Final Environmental Impact Report

for Los Angeles International Airport (LAX) Landside Access Modernization Program

Responses to Comments, Corrections & Additions to the Draft EIR

FIGURE 1
STUDY INTERSECTIONS WITH JULY TRAFFIC COUNTS

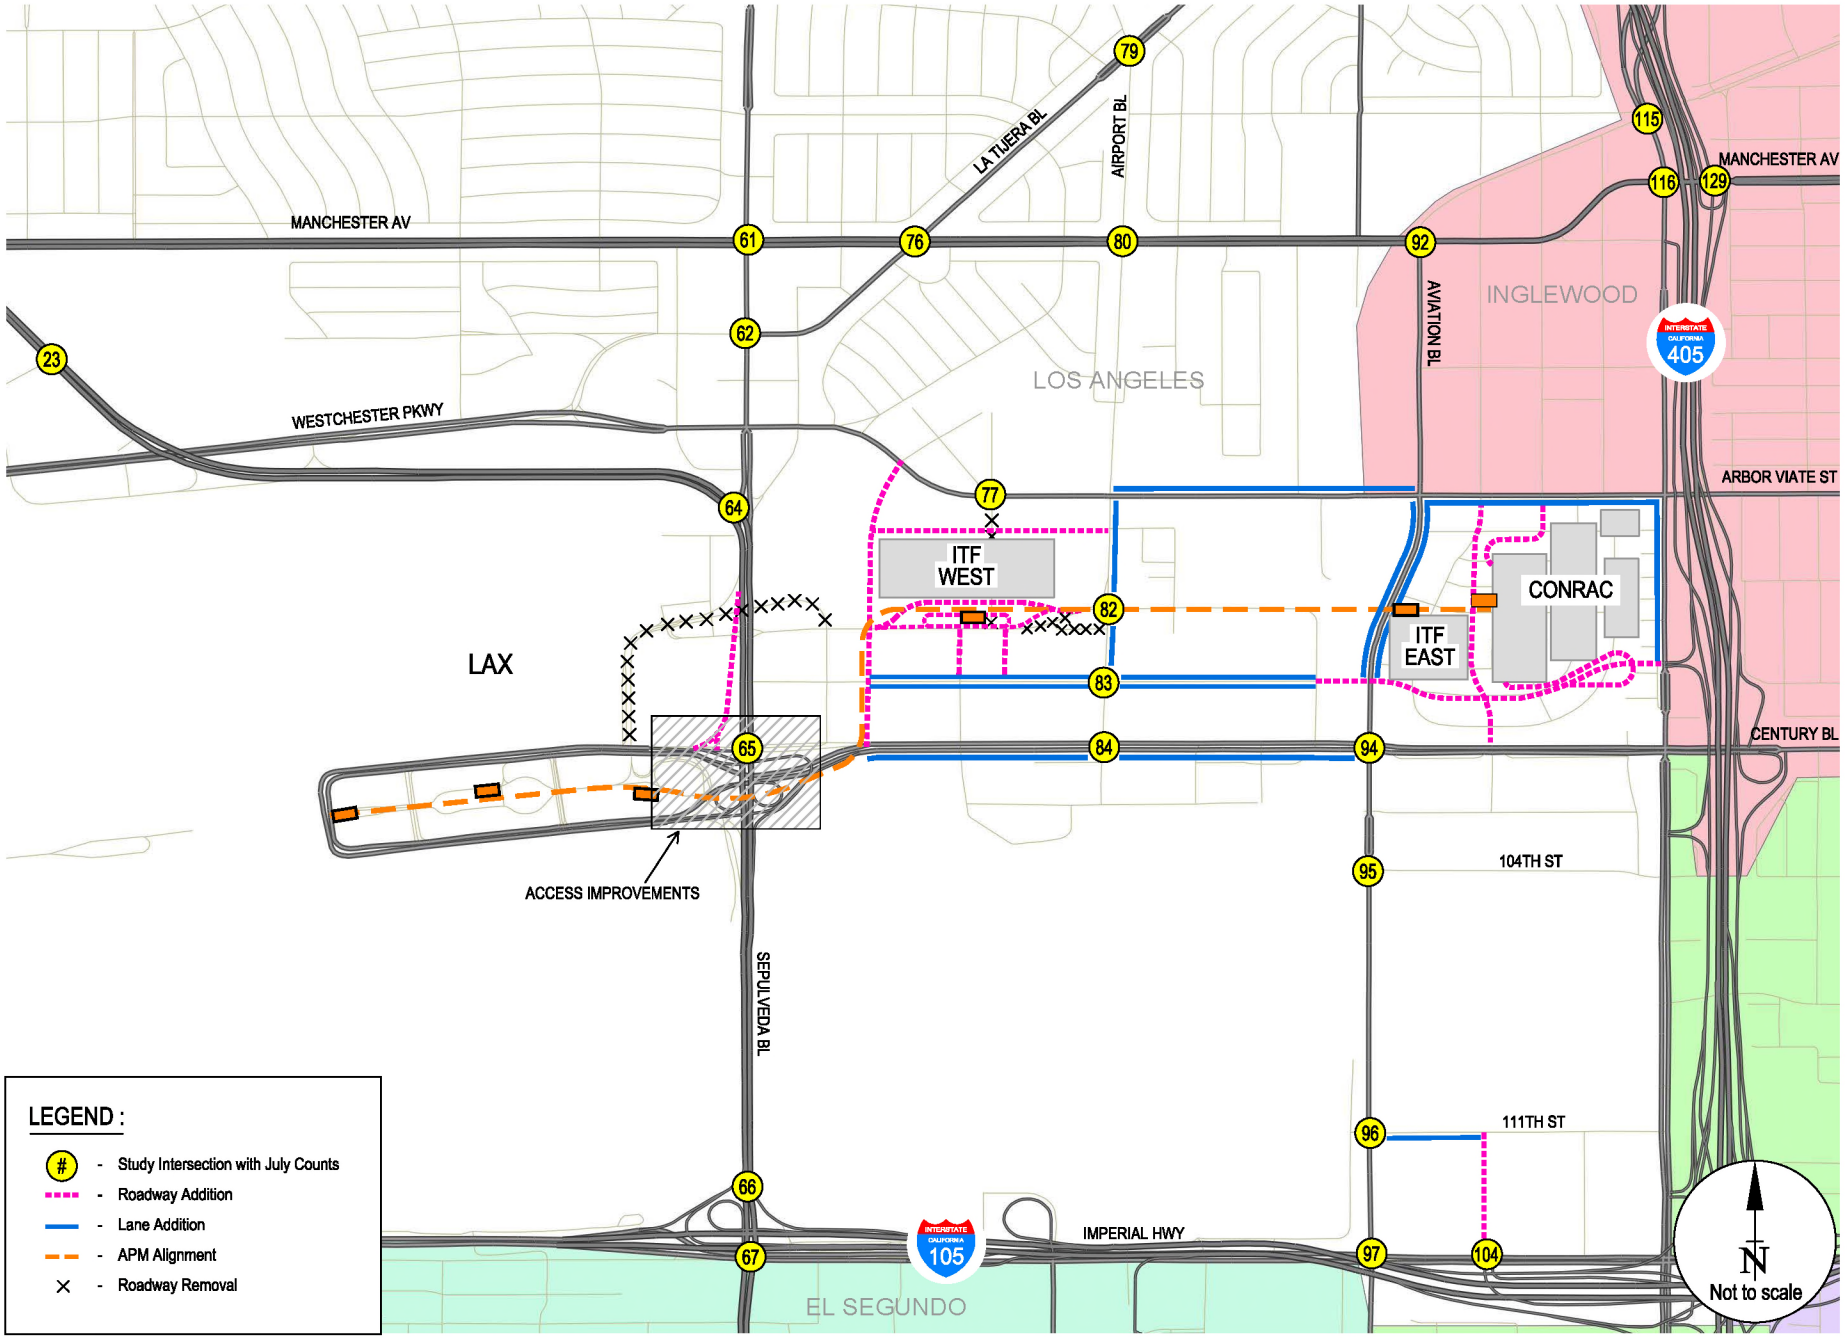
Metro was commencing construction activities associated with the LAX/Crenshaw light rail line within the study area in July 2015 and was shutting down travel lanes along Arbor Vitae Street, Aviation Boulevard, Century Boulevard and Imperial Highway. LAWA conducted traffic counts at 23 locations in July 2015 (See Figure 1) in the vicinity of the impending lane closures prior to closure of travel lanes along the facilities noted above. These locations also happen to be those that are adjacent to LAX and its facilities, and consequently, are also those with higher summer traffic volumes. As shown in Table 4.12.1-2 of the Draft EIR, the peak month for traffic in the CTA varies between June, July, and August from year to year. Thus, traffic counts taken in July 2015 are representative of peak traffic within the CTA.

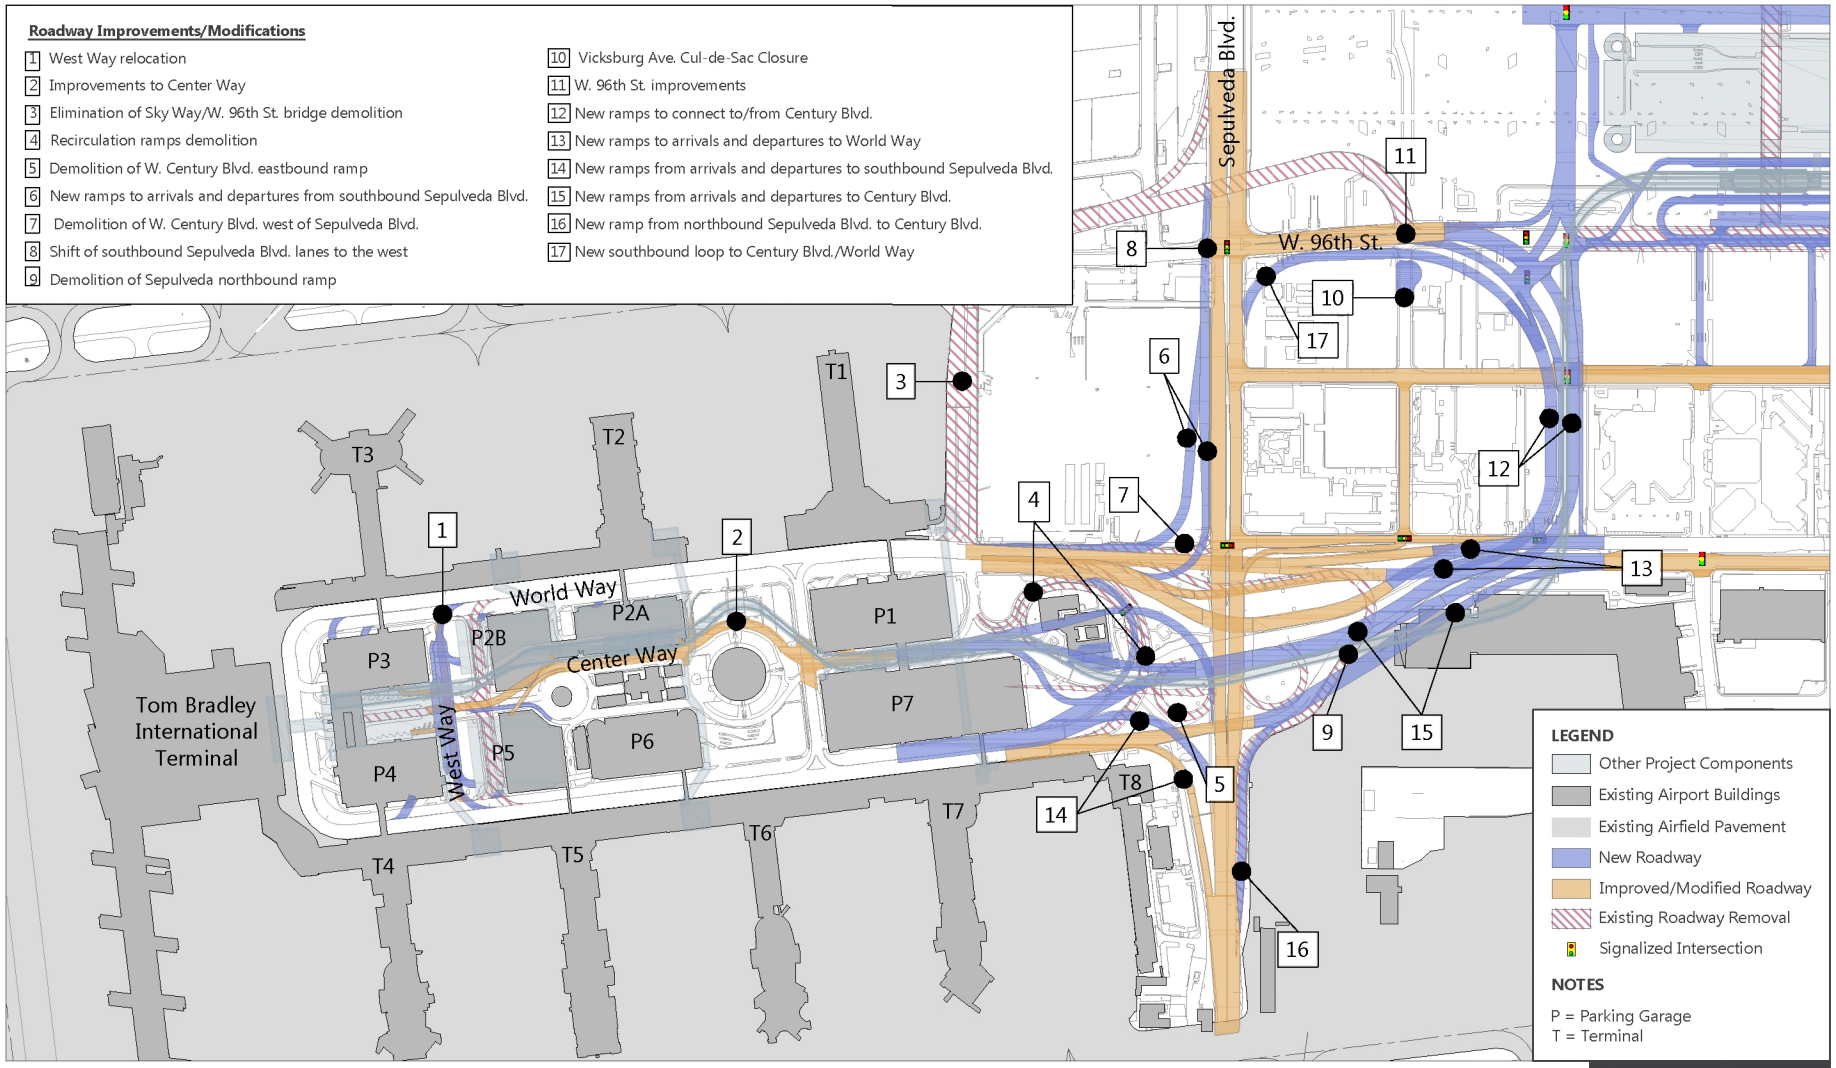
8. Figure 2-41: Roadway Improvements – Central Terminal Area on page 2-133 of the Draft EIR is hereby revised to change the roadway improvement to Vicksburg Avenue between W. 96th Street and W. 98th Street (Map Key ID #10) per the correction above. Please see the following revised figure. This correction also applies to the following figures: 2-49, 4.12.1-7, 5-4, and 5-6.

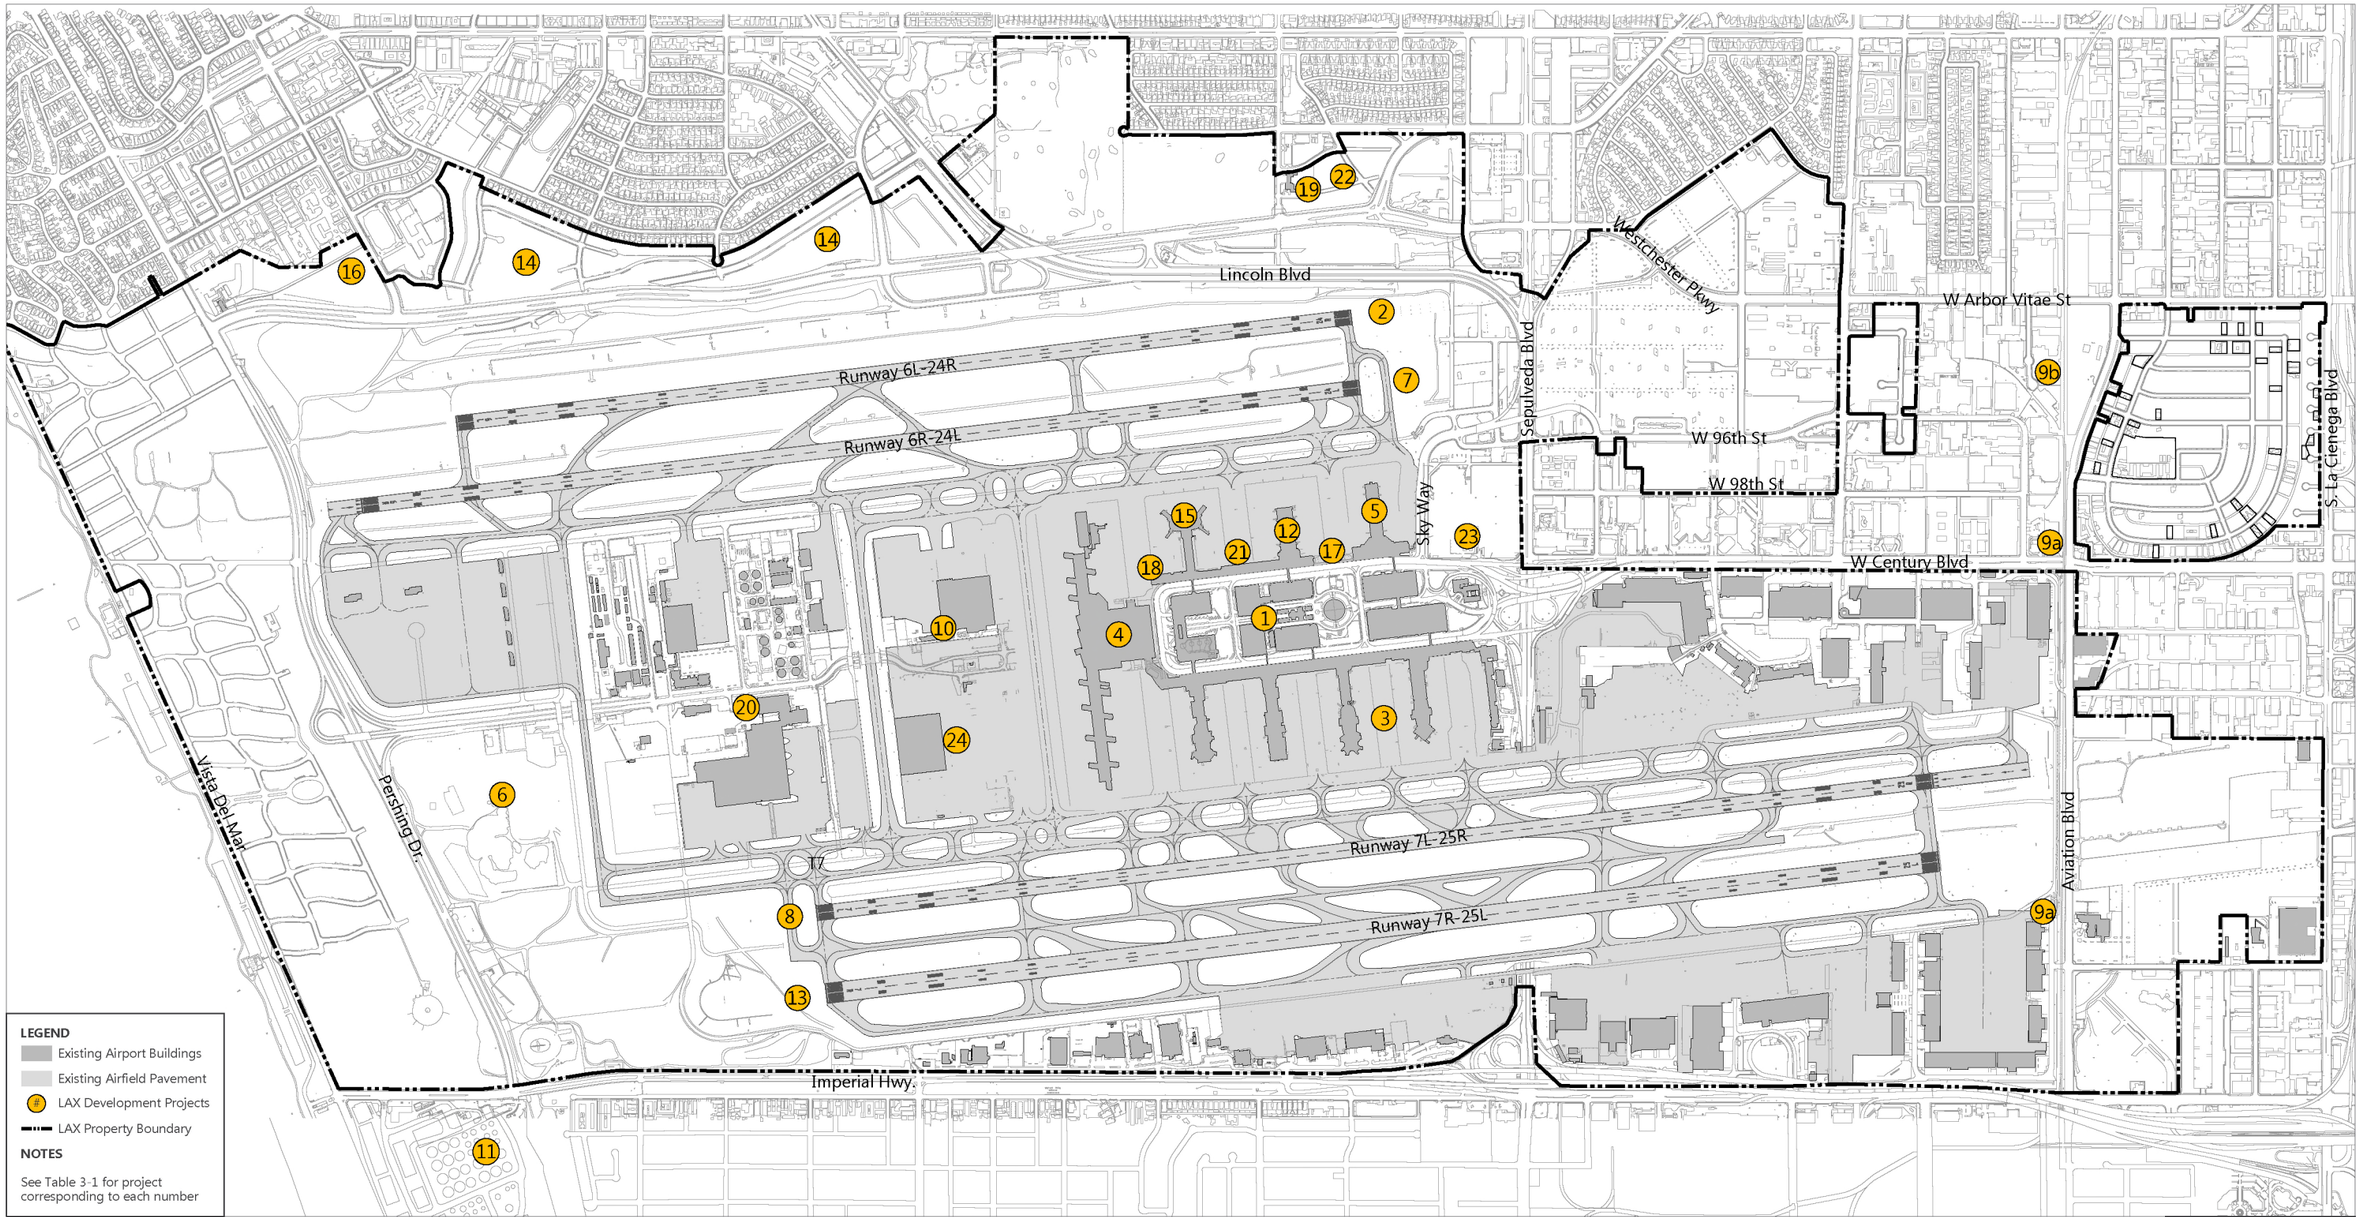
Response: In response, Project 9 information in Table 3-1 on page 3-10 of the Draft EIR has been revised as shown below. In addition, Figure 3-1 on page 3-13 of the Draft EIR has been revised to reflect the revision to Table 3-1. Please see Chapter 3, Corrections and Additions to the Draft EIR.

4. Figure 3-1: Development Projects At/Adjacent to LAX on page 3-13 of the Draft EIR is hereby revised to reflect the change to Project 9 information in Table 3-1 shown above (to identify the Airport Metro Connector (AMC) 96th Street Transit Station as a separate project from the Metro Crenshaw/LAX Transit Project). Please see the following revised figure.

FIGURE 8
EXISTING AND PLANNED BICYCLE FACILITIES

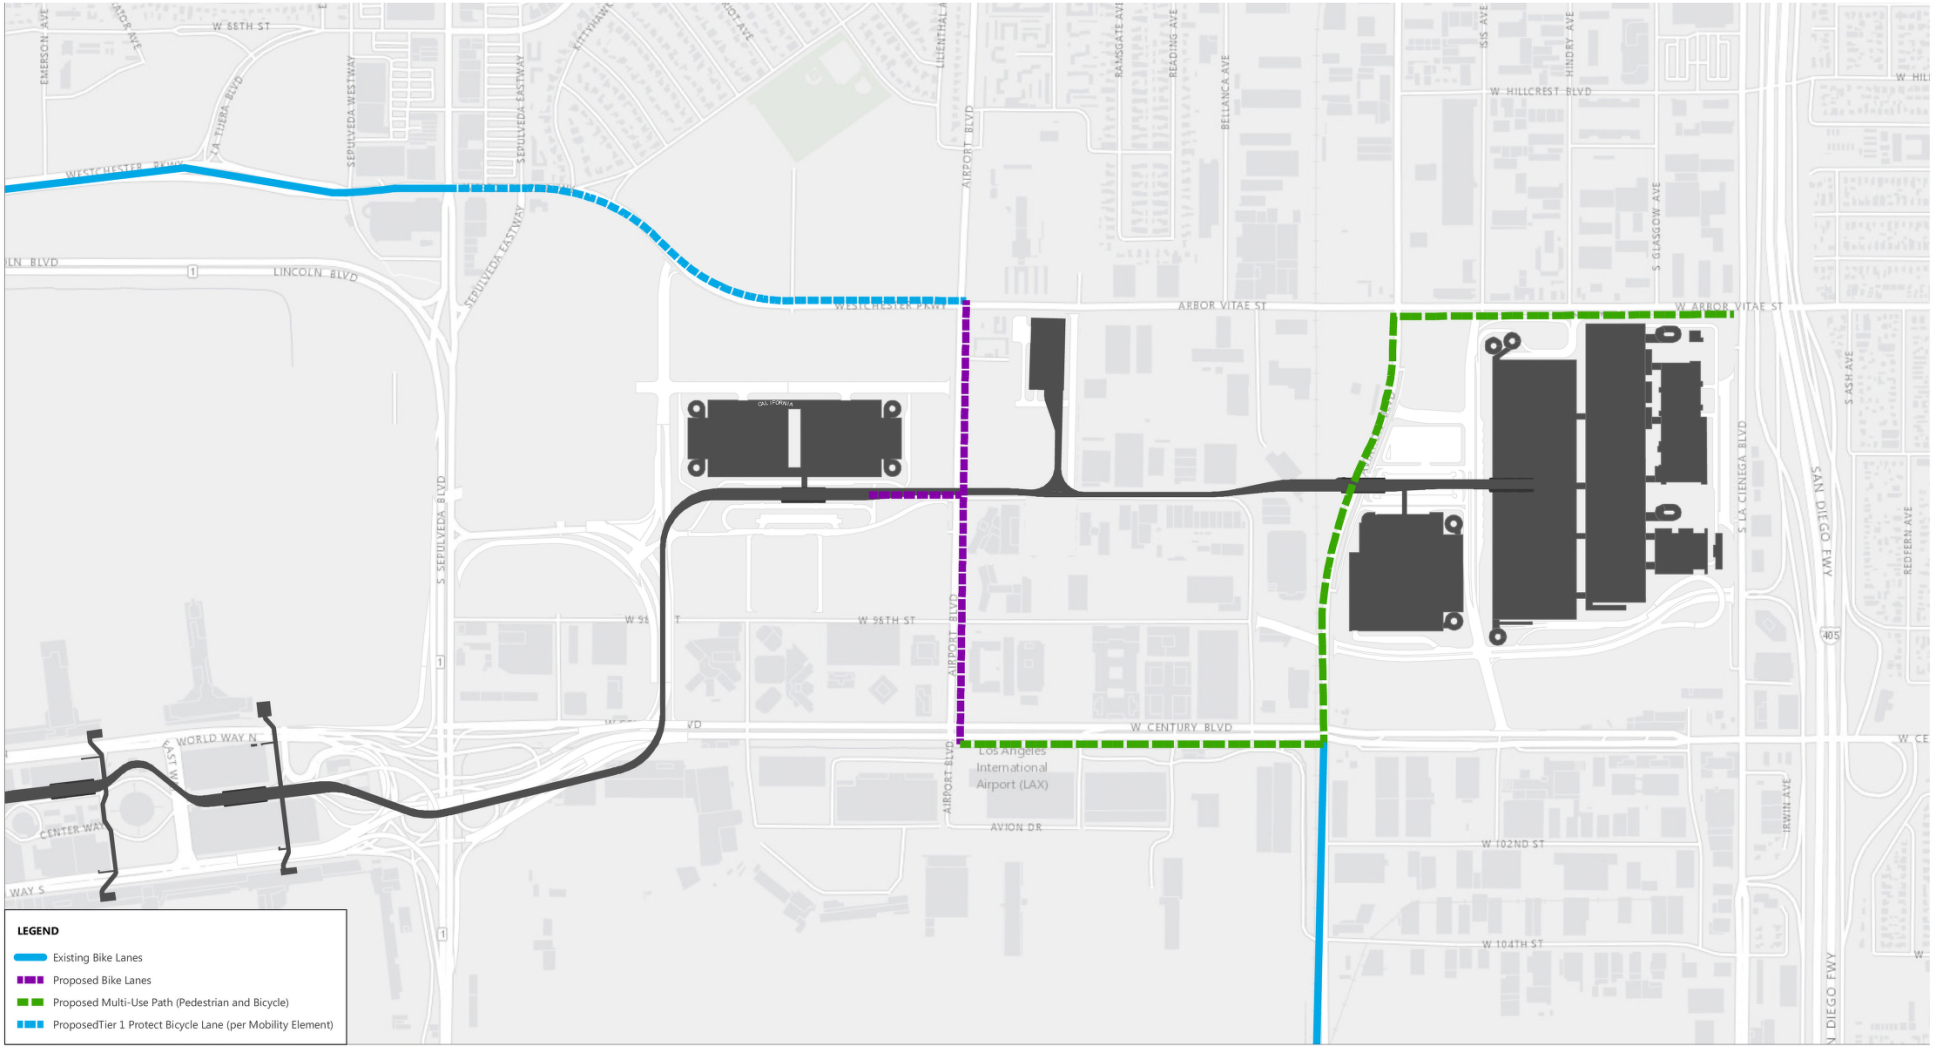
Comment: Existing and planned bicycle facilities are presented in Appendix O, Off-Airport Traffic. Figure 8, Existing and Planned Bicycle Facilities, DEIR Appx. O, p. 69. The proposed bicycle facilities described in that graphic appear to be somewhat inconsistent with those described in the DEIR elsewhere. See DEIR, Figure 2-55, p. 2-203. A clarification of the conflict between proposed facilities is necessary.

Comment: Finally, to the extent that bicycle facilities are not planned to extend further west on Century Boulevard than Airport Boulevard, 6171 Century suggests that the proposed Multi-Use Path be extended along the north side of W. Century Boulevard from Airport Boulevard to S. Sepulveda Boulevard. Alternately, a similar bicycle facility could be made part of 98th Street west of Airport Boulevard as shown in the above-cited Figure 8. DEIR Appx. O, p. 69.

Response: The LAX Landside Access Modernization Program proposes to modify the Bike Plan as included in the existing Mobility Plan 2035 (see Figure 2-55 of the Draft EIR). In addition, the proposed ITFs would be designed to incorporate bicycle and pedestrian facilities, including bicycle parking and changing/shower facilities (see page 2-147 of the Draft EIR). The proposed Bicycle Plan as shown on Figure 2-55 is correct; the Figure 8 on page 69 in Appendix O of the Draft EIR is incorrect. A corrected Figure 8 is included in Chapter 3, Corrections and Additions to the Draft EIR; this correction does not result in any new or substantially more severe significant environmental impacts.

Response: The LAX Landside Access Modernization Program proposes to modify the Bike Plan as included in the existing Mobility Plan 2035 (see Figure 2-55 of the Draft EIR). Under the proposed Project, bicycle access would be maintained from connections along Westchester Parkway/W. Arbor Vitae Street, Airport Boulevard, Century Boulevard and Aviation Boulevard. The commentor suggests an extension of the multi-use path along Century Boulevard to the west of Airport Boulevard; however, the property on the north side of W. Century Boulevard is not owned by LAWA and there would be no place for a bike path to connect to on the south side of Century Boulevard. As noted in the Response to Comment LAMP-PC00029-5, the proposed ITFs would be designed to incorporate bicycle and pedestrian facilities, including bicycle parking and changing/shower facilities (see page 2-147 of the Draft EIR).
